**Project
T10/1683-D**

**Information technology -
SCSI Architecture Model - 4 (SAM-4)**

Summary of Comments on SCSI Architecture Model - 4

Figure 1 — Requirements precedence

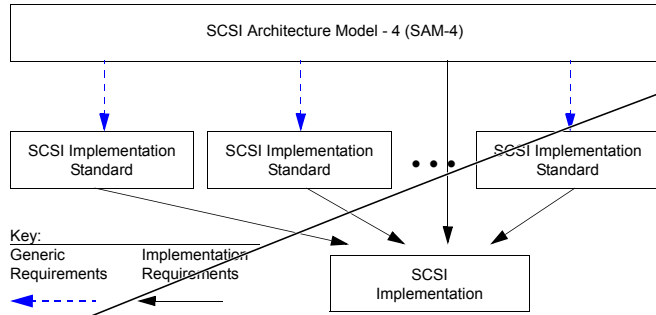
Author: Mark Evans, WDC Subject: Highlight Date: 10/25/2007 1:01:53 PM
 Since text takes precedence in this standard, and text should introduce figures, tables, etc., I recommend moving the following paragraph above figure 1.

Status George Penokie Accepted 10/26/2007 2:31:33 PM
 Author: Mark Evans, WDC Subject: Note Date: 10/25/2007 1:03:15 PM
 I recommend that at least one "e.g." be added either in the four rows in figure 2, in the descriptive text that follows, or both. See SBC-3 for an example.

Figure 2 — SCSI document structure

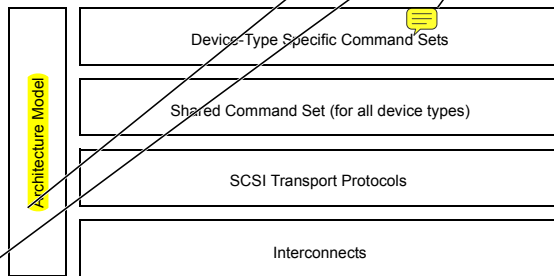
Status George Penokie Accepted 10/29/2007 3:50:40 PM
 Author: Emulex Subject: Highlight Date: 10/30/2007 1:16:34 PM
 Emulex-001
 Page: 2 first sentence below Figure 2 - "roadmap" s/b "document structure"

Status George Penokie Rejected 10/29/2007 4:06:27 PM
 Author: George Penokie Subject: Note Date: 10/26/2007 2:33:21 PM
 Copied the SBC-3 figure into SAM-4.

Figure 4 — Notation for association relationships for class diagrams

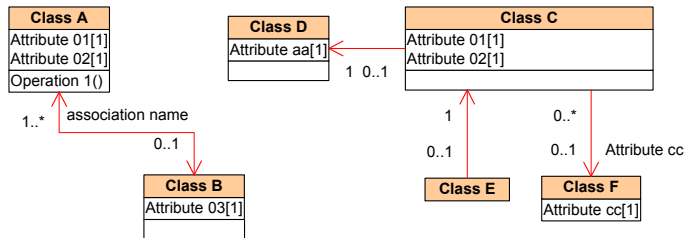
Author: Mark Evans, WDC Subject: Highlight Date: 10/29/2007 1:19:21 PM
 *Solid lines with arrowheads (see figure 4) are the notation...
 sfp
 "...is the notation..." ["notation" meaning, "...any particular system of characters or symbols used to briefly express elements...", and this is my first choice]
 or
 "...are the notations..." ["notations" meaning, "...the characters or symbols used in such a system...]
 One way or the other, the verb has to agree with the object (i.e., either "is the notation" or "are the notations").
 Status
 George Penokie Accepted 10/29/2007 10:25:26 AM
 Author: George Penokie Subject: Note Date: 10/29/2007 10:25:18 AM
 Changed to "is the notation"

Figure 5 — Notation for aggregation relationships for class diagrams

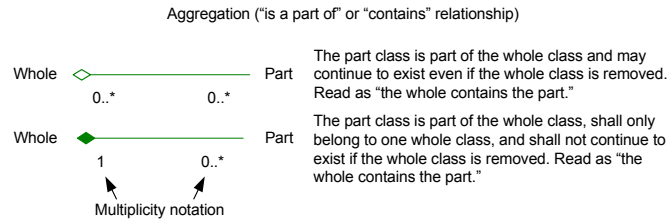
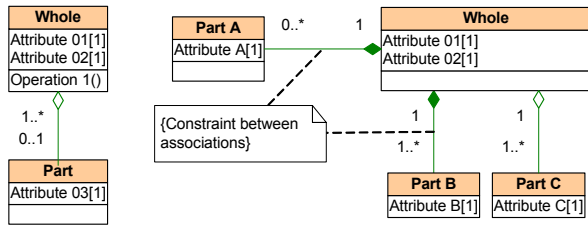
Author: Mark Evans, WDC Subject: Highlight Date: 10/29/2007 1:18:53 PM
 *Solid lines with diamonds (see figure 5) are the notation...
 s/b
 *...is the notation... [see my earlier comment]
 Status
 George Penokie Accepted 10/29/2007 10:26:15 AM

Figure 12 — SCSI client-server model

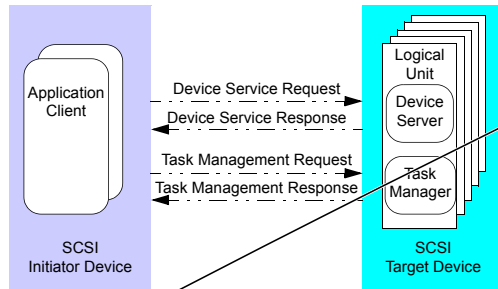
- Author: relliott Subject: Note Date: 10/28/2007 10:37:45 PM
 The last paragraph in 4.3.1 discusses commands and device server requests. It should also discuss TMFs and task management requests, to cover everything shown in figure 12.

Figure 15 — SCSI Domain class diagram

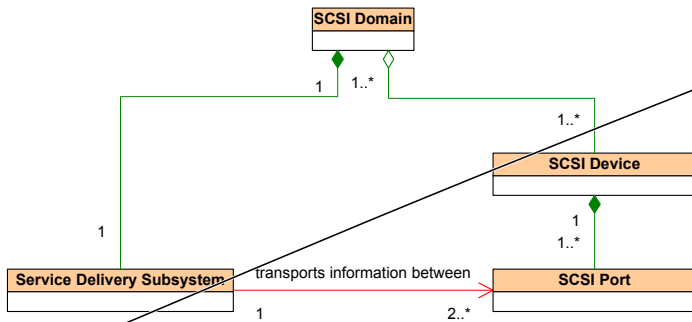
Author: relliott Subject: Highlight Date: 10/8/2007 6:53:52 PM
 SCSI Domain class (figure 15)
 s/o
 SCSI Domain class (see figure 15)

Status
 George Penokie Accepted 10/30/2007 3:42:44 PM

Figure 19 — SCSI Initiator Device class diagram

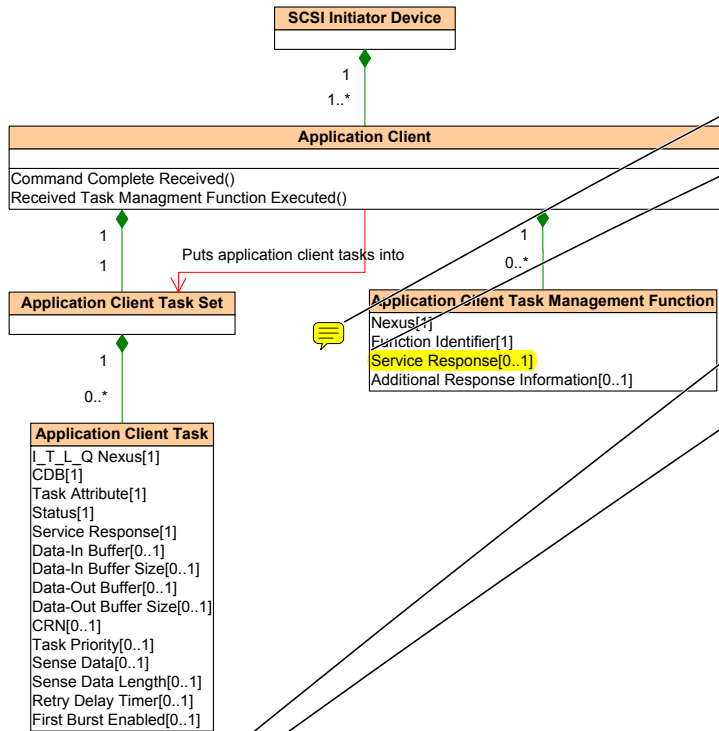
Author: reilott Subject: Note Date: 10/8/2007 6:53:04 PM
 Nexus and Function Identifier should be swapped in figure 19 and in sections 4.5.11.2 and 4.5.11.3 to match the SCSI Target Device side in figure 22 and following sections. (or the target side should be swapped to follow this)

Figure 22 — Logical Unit class diagram

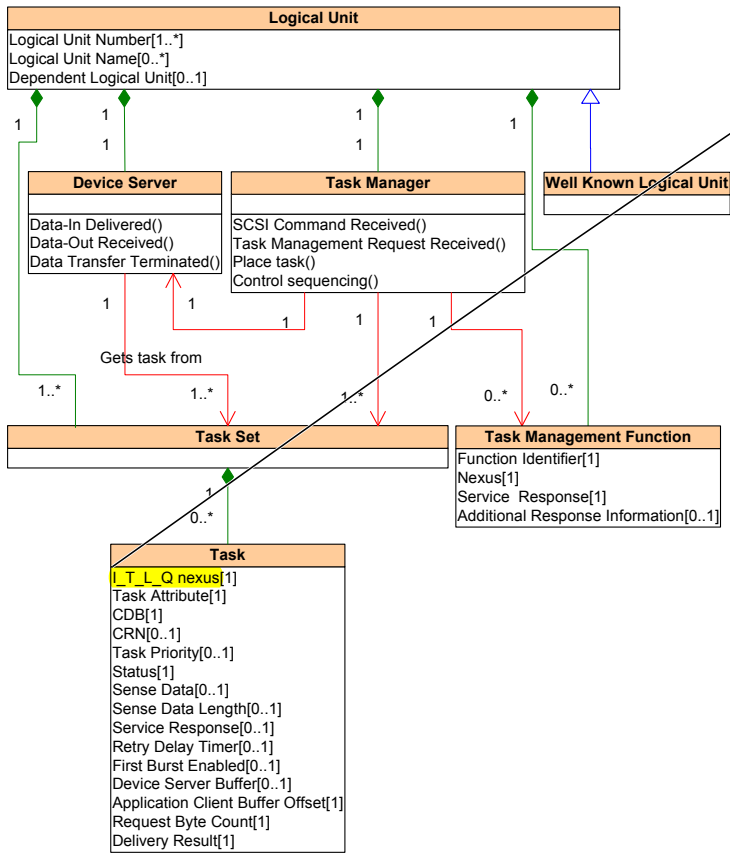
There is no class with that name, and it doesn't appear in figure 22.

Author: relliott Subject: Highlight Date: 10/8/2007 6:46:29 PM
4.5.24.3 should be swapped with 4.5.24.2 to match the order the attributes are listed in figure 22.

Status
George Penokie Accepted 10/30/2007 5:05:22 PM Date: 10/30/2007 5:05:06 PM
Author: George Penokie Subject: Note
Deleted the entry as it was a hold over from a previous version of the UML.

Figure 4 — Notation for association relationships for class diagrams

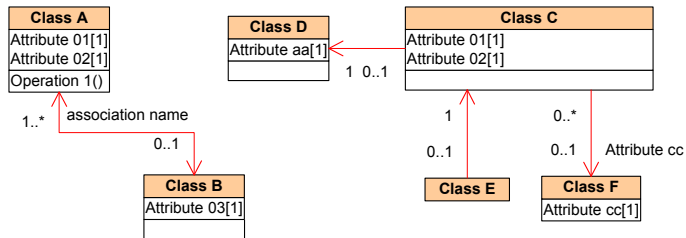
"is" is very awkward given that all the nouns on the left are plural.
Restructure as
*The notation used to describe the association relationship between classes in class diagrams is solid lines with arrowheads (see figure 4).
Apply to all the figure introductions in this section.
